145 Havant Road,
Hayling Island,
Hants.

Ref. APP/11/01585.

Ref our telephone conversation this morning and my request to change the design of a window at building works being undertaken at the above address.

COPIED FROM PLAN A103 - SOUTH ELEVATION: SCALE 1:100 AT A1

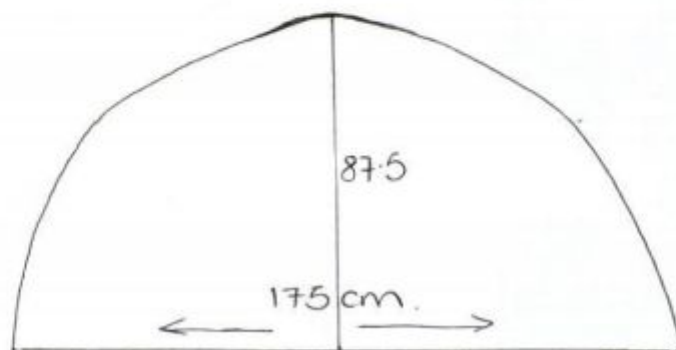
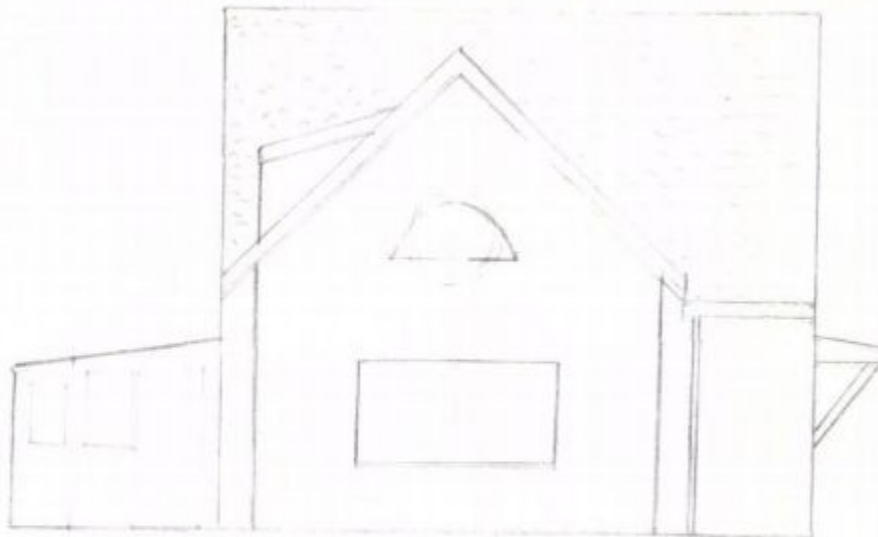
As you requested I have drawn to scale the proposed change from a circular window to an arch window.

I was initially advised that if I ensured that the size of the circular window was the same area as that of the two original square windows on this aspect of the building combined, then this would satisfy objections raised. To this end I have ensured that the total area of the arch window would also be the same (actually a little less) as that of the two square windows combined. I provide the following calculations in respect of this:

For 87.5cm radius arch. = $\frac{3.142 \times 87.5^2}{2} = 12,027.9 \text{ cm}$
(Note: slightly less than allowed).

$\therefore$ Diameter (base) of arch = $87.5 \times 2 = 175 \text{ cm}$.

On the scale drawing you can see that the depth of the arch is less than the circle, and thus viewpoint is actually decreased. The arch is slightly wider, but this is only at base / sill level and from a viewpoint perspective it is narrower than that of the 2 original windows, which from the edge of one to the edge of the other was 1.86 m (compared to the 1.75 of the arch base).

I am requesting this minor change in order to flatten the base of the circle and thereby avoid potential damp / leakage problems.
